## **MERRYFIELD HALL**

**ADA ASSESSMENT & SURVEY**

Re: ADA Accessibility Survey and Assessment – Merryfield Hall

| Field Date:   | 6/28/2011 Report Date 6/28/2011 Barrier #: 248A   |

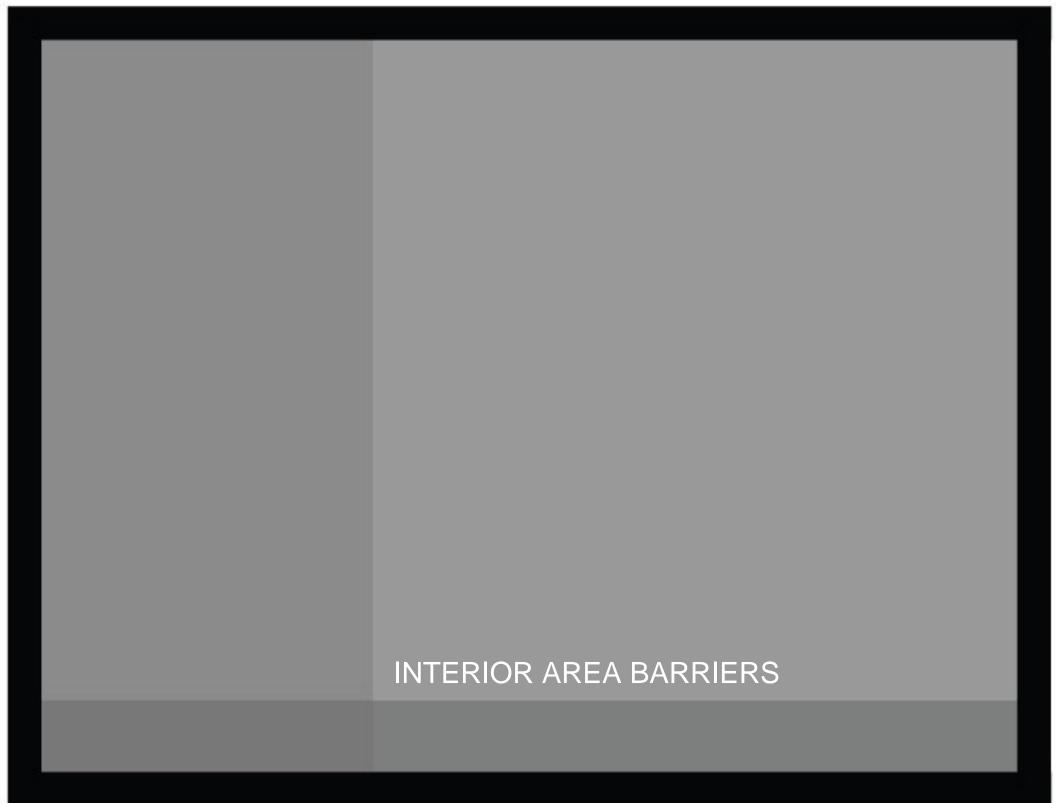
| Field Date:   | 11/16/2011 Report Date ######## Barrier #: 244  |
|---|---|
| Bldg Name: Location: X Coordinate: Barrier Area: Barrier Type: Code References: Performance Sta Barrier Description: Findings:                | Merryfield Hall Reference Dwg: 1 of 3  Exterior - Covell Hall/Graf Hall - Parking Lot  7479198.819 Y Coordinate: 340801.834  Parking  Stall Dimensions - New Construction  OSSC 1104.4.3  ndard: No Quantity: SF As-built: 100  Accessible stall & aisle not max. 2.0% in all directions  2.6%  |
| Bldg Name: Location: X Coordinate: Barrier Area: Barrier Type: Code References: Performance Sta Barrier Description: Findings: Rec. Solution: | Merryfield Hall Reference Dwg: 1 of 3  Exterior - Covell Hall/Graf Hall - Parking Lot  7479198.819 Y Coordinate: 340801.834  Parking  Stall Dimensions - New Construction  OSSC 1104.4.3  Indard: No Quantity: SF As-built: 100  Accessible stall & aisle not max. 2.0% in all directions  2.6%  Regrade stall to make level and restripe  2 Recommended Cost Est \$0.00 Facility Function: Public Status: Open |
